Technical Service Bulletin Number	Revision Level	Date	Group Number
TSB140130	SB-10056801-5708

Peterbilt™ 365LC Car Haulers with ISX12 CM2350 X102 Fuel Actuator Inlet Metering Valve Clearance Issues

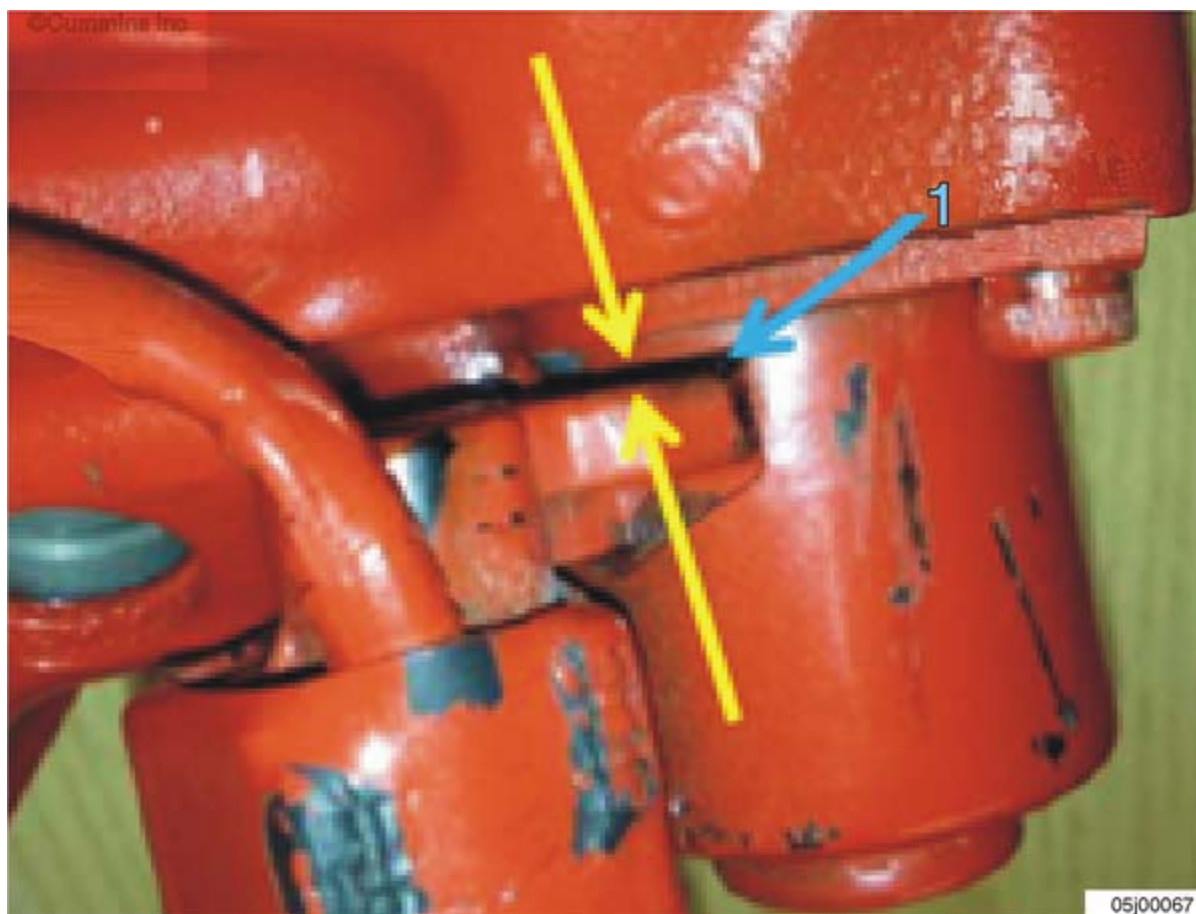
Peterbilt™ 365LC car haulers with the ISX12 CM2350 X102 required the inlet metering valve to be clocked for clearance of the cab floor at the time for production build for the first 97 units.

The clocking of the inlet metering valve puts the assembly components in a bind, leading to malfunction. The clocking of the inlet metering valve leads to premature malfunction of the valve.

1. Larger or uneven gap.

Contact Peterbilt™ for repair action. Repairs require modification to the cab floor to provide proper clearance for the inlet metering valve. Install a new inlet metering valve assembly.
